SUBJECT: IP REQUEST FOR EXPERT REVIEW OF KRSKO PLANT CHANGES

DRAFT FSAR CHANGES

KRS10 FEEDWATER SYSTEM MODIFICATION

FOR SPLIT FLOW OPERATION

VE KRSDO FSAR Fig. 15.2-23

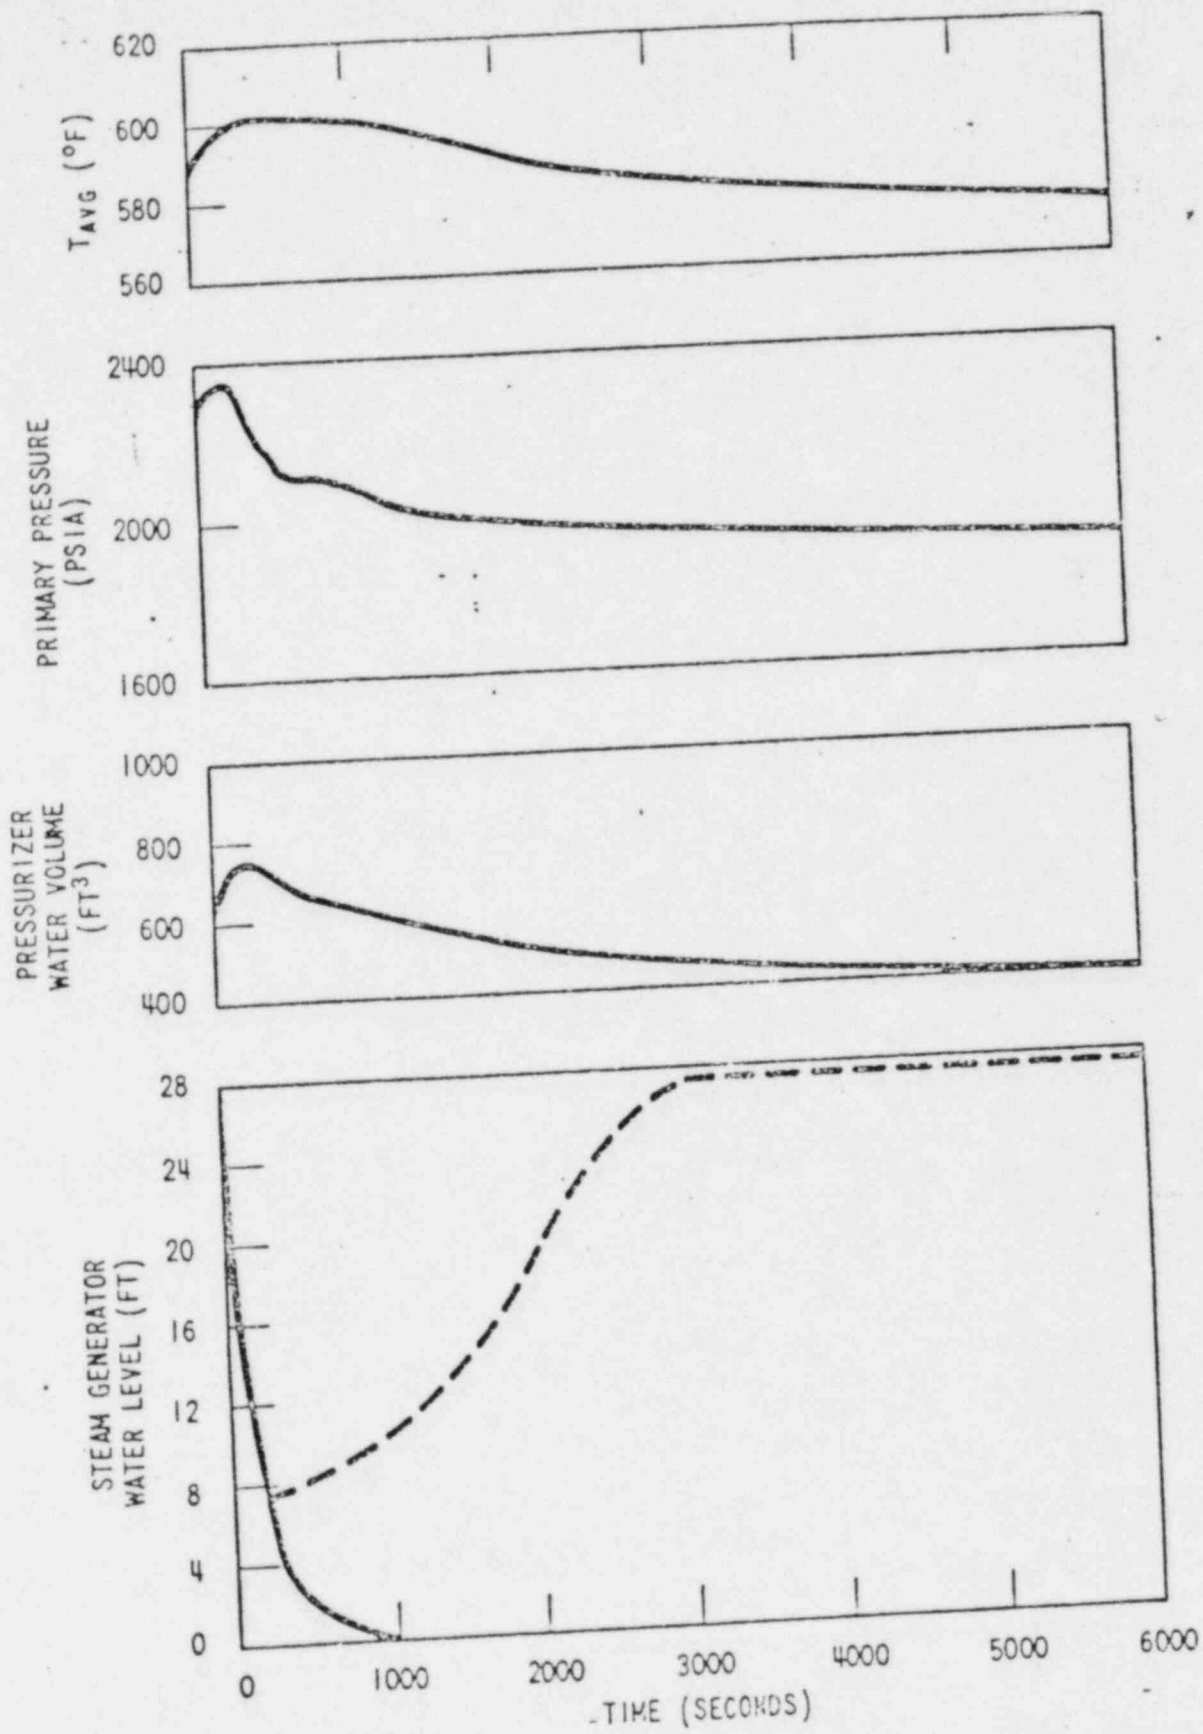
Replace with new figures

Fig. 15.2-24

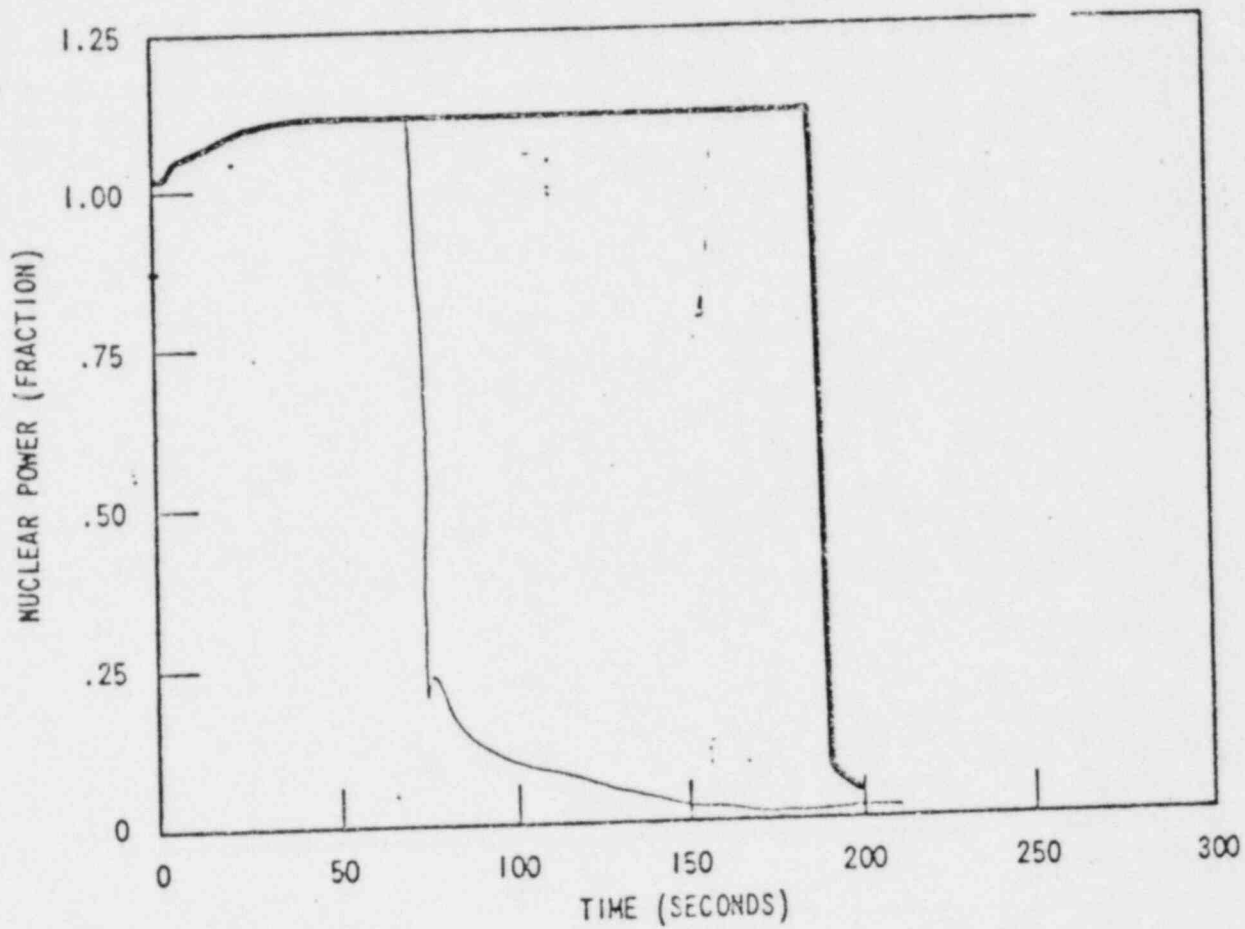
replace with new figure

VE KRSD FSAR Fig. 16.2-25

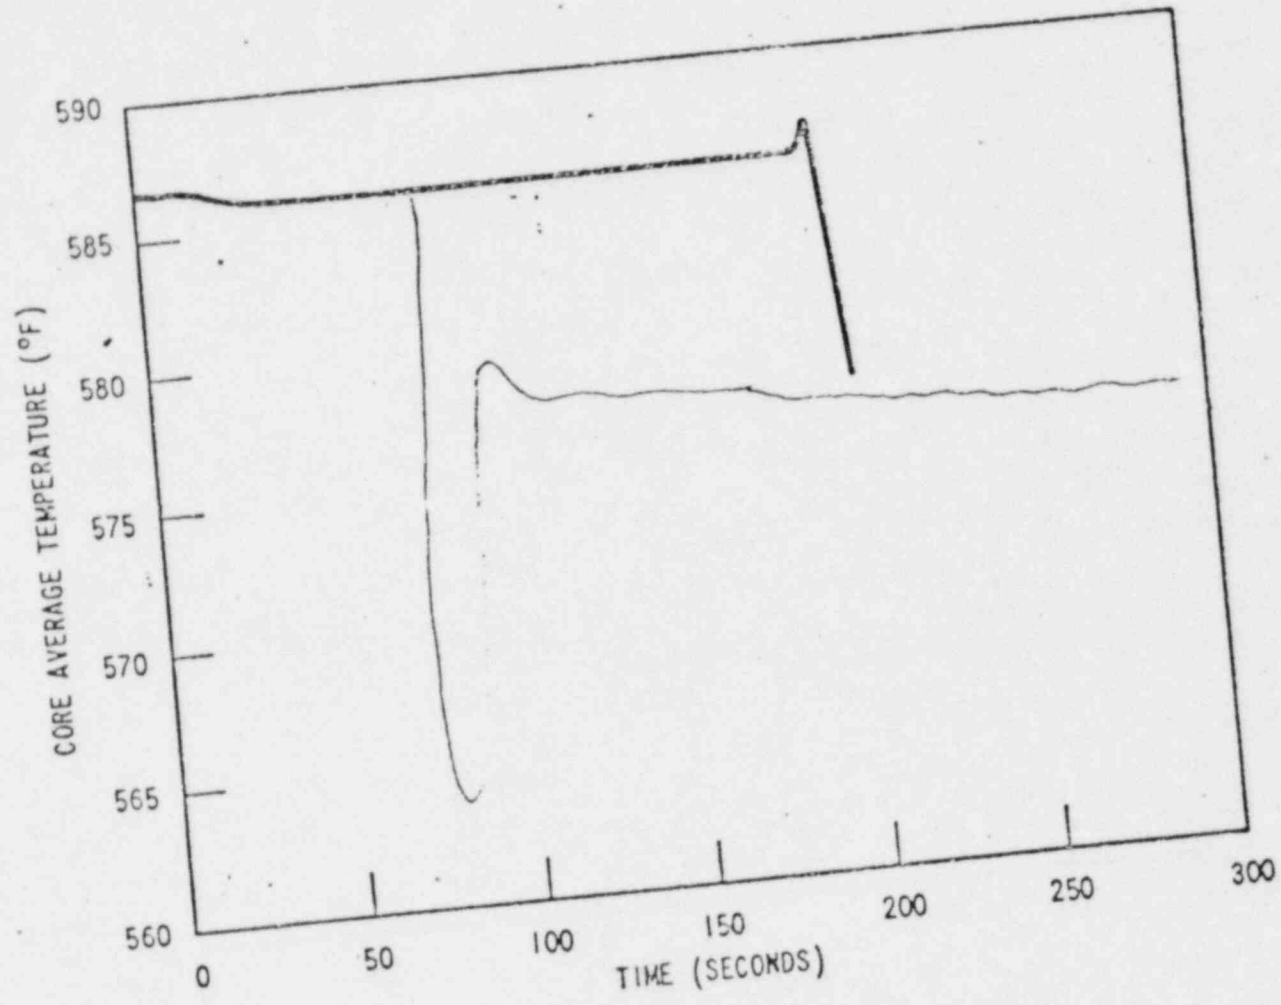
replace with new figure
